Development Control B Committee Supplementary Information

a) 20/00433/F - The Hawthorns Woodland Road

**Review of Transport Information - Planning Application 20/00433/F - The Hawthorns
Woodland Road Bristol BS8 1UQ**

Project title	University of Bristol New Library and Public Realm	Job number	267549-00
cc		File reference	4.50
Prepared by	RH	Date	3 November 2020
Subject	Response to IMA Transport Planning Technical Note

Figure 1: Average weekday traffic flows on Elton Road (October 2019 ATC data)

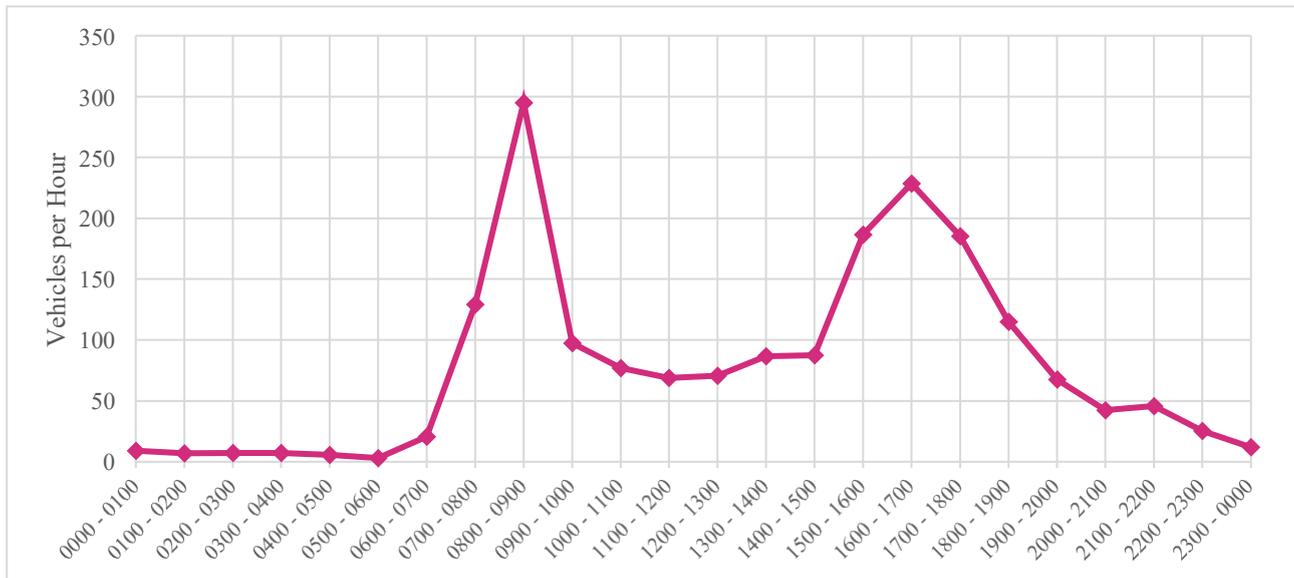
As can be seen in Figure 1, observed two-way traffic flows on Elton Road in term-time are significantly higher during the AM and PM peak hours, coinciding with school pick-up/drop-off times, but still extremely low overall (five vehicles per minute on average across the AM peak hour). However, during the remainder of the school day when pupils are more likely to be crossing between different teaching premises, traffic flows are significantly lower and so the impacts of any additional traffic on the convenience of pupils waiting to cross the road would be minimal.

Fig 1: BRE DLSL decision making flow chart © BRE Trust showing default route

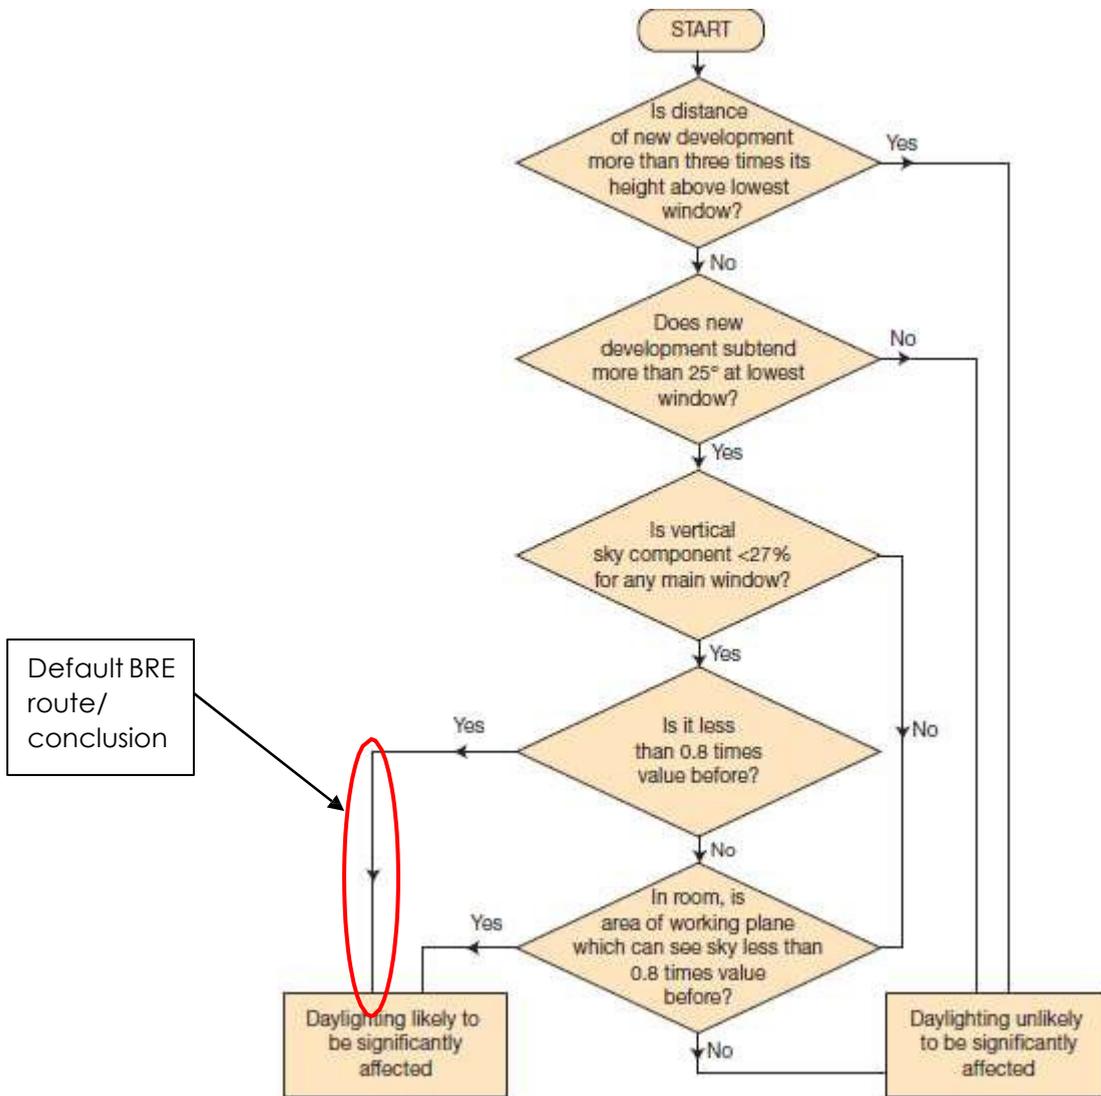
In addition, the logic regarding acceptability is contrary to the BRE guidance flow chart, which sets out that failure of one test is a failure overall and therefore not an either/or test.

As can be seen, the default route based on the VSC results in themselves would lead to the conclusion that daylighting to the classrooms is likely to be significantly affected.

Avison Young have replicated figure 1 from the BRE guide within their letter and highlight one strand of the flowchart with a binary choice as to whether the VSC and DD results are less than 0.8 times their former value. However, in doing so, either deliberately or inadvertently, they ignore exercising any degree of flexibility as recommended in paragraph 1.6 of the guide (replicated above). We have clearly outlined reasons of mitigation that are accepted as 'the norm' by fellow practitioners and local authorities. We do not accept a conclusion that the daylighting to the classrooms will be significantly impacted.
